**IMO - Union submission to be submitted to the 7th of the Sub-Committee on Ship Systems and Equipment (SSE 7) of the IMO in London from 2 – 6 March 2020 concerning proposed amendments to the LSA Code and Resolution MSC.81(70) to address the in-water performance of SOLAS lifejackets**

**DEVELOPMENT OF AMENDMENTS TO THE LSA CODE AND RESOLUTION  
MSC.81(70) TO ADDRESS THE IN-WATER PERFORMANCE OF SOLAS LIFEJACKETS**

**Proposal for amendments to the LSA Code and Resolution MSC.81(70) to address the in-  
water performance of SOLAS lifejackets**

**Submitted by the European Commission on behalf of the European Union**

**Figure 3 - Shoulder lift test arrangement for lifejackets**

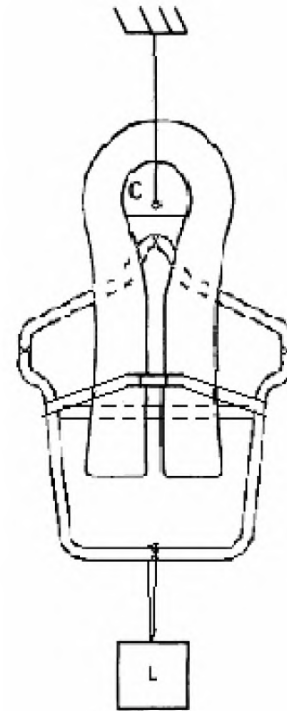
**2.5.2** This test shall be conducted both with and without the ride-up prevention system correctly fitted. The lifejacket should be immersed in water for a period of 2 min. It should then be removed from the water and closed on a form as shown in figure 2, in the same manner as when it is worn by a person. A force of not less than 900 N (700 N in the case of a child- or infant-size lifejacket) should be applied for 30 min across the form and the shoulder section of the lifejacket (see figure 3). The lifejacket should not be damaged as a result of this test. The lifejacket should remain secured on the form during this test.
